Re: Minor Project Refinement No. 5 for the South Orange County Reliability Enhancement Project.

ATTACHMENT A
MPR-5 Form

South Orange County Reliability Enhancement Project CPUC Minor Project Refinement Form

**MPR-5 Figure 1
Structure Location 10**

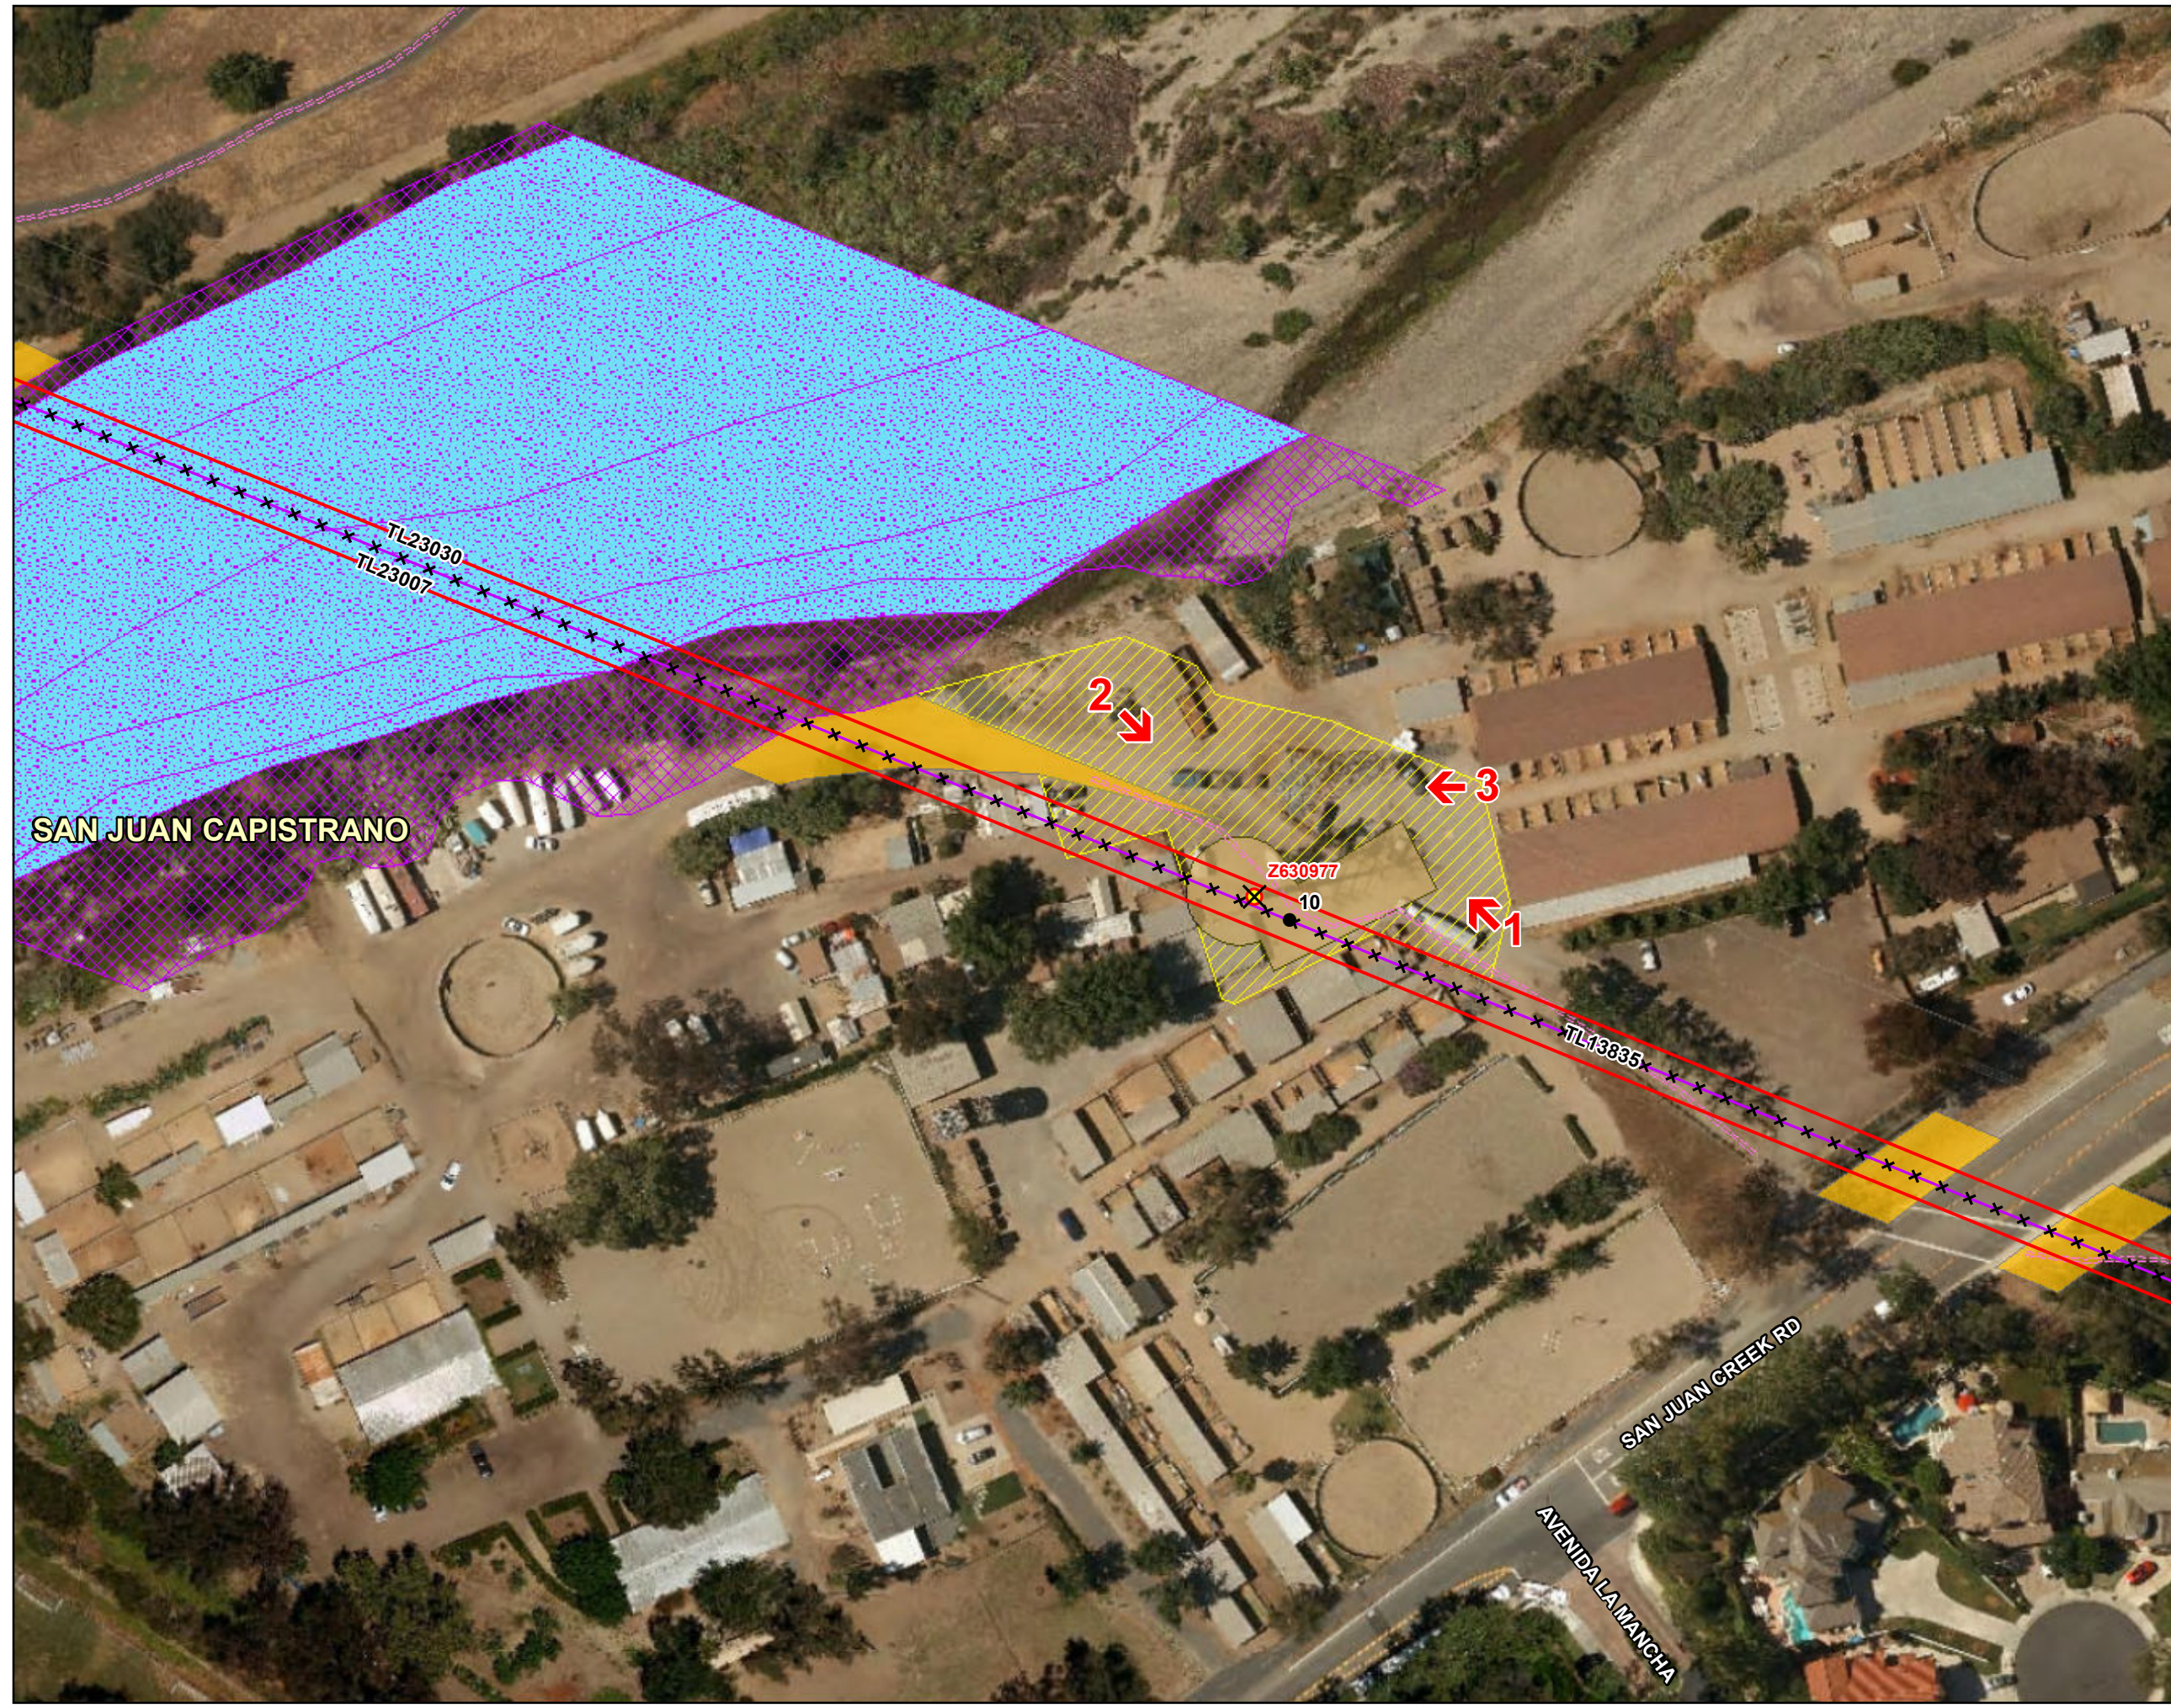
San Diego Gas and Electric (SDG&E) is requesting approval of MPR-5 for a new temporary work area required to facilitate construction of Location 10 for the South Orange County Reliability Enhancement Project (SOCRE or Project). The new temporary work area surrounds the existing work area for Location 10 and existing pole Z630977, previously approved in Notice to Proceed No. 6 (NTP-6) at Tar Farms Stables. The new MPR-5 work area will total approximately 22,026 square feet (0.5 acre).

The additional MPR-5 work area is necessary to safely and efficiently complete the installation of Location 10. Due to the presence of groundwater encountered beneath the surface during preliminary borings, the method of installation will require more equipment to be on site at one

The MPR-5 work area will be used for temporary materials and equipment laydown and will provide additional space to be used for drilling, hauling, concrete and crane operations associated with Location 10 construction. The additional work area will also allow adequate space for equipment to safely park and maneuver during Location 10 installation activities. There will be no trees or vegetation removed within the MPR-5 work area. The MPR-5 work area will be utilized for approximately 3 months and activities will begin immediately following MPR-5 approval. Following the use of the MPR-5 temporary work area, the area will be restored to pre-Project conditions based on pre-Project photo documentation by SDG&E, and in coordination with Tar Farms Stables. **Attachment B, MPR-5 Figure** shows the location of the MPR-5 temporary work area.

Justification for Change: Following final design and constructability review in the field, the construction contractor identified the need to gain access to the MPR-5 work area in order to facilitate the construction of Location 10, as there is not enough room within the previously approved work area to safely and successfully perform the Location 10 pole installation. The additional MPR-5 work area will be used for temporary laydown of materials and equipment and will provide additional space to be used for drilling and crane operations associated with Location 10 construction. The additional temporary work area will also allow adequate space for equipment to safely maneuver and turn around during Location 10 installation activities (See **Attachment B, MPR-5 Figure**). There will be no trees or vegetation removed within the MPR-5 work area, and no additional access to the MPR-5 work area will need to be constructed.
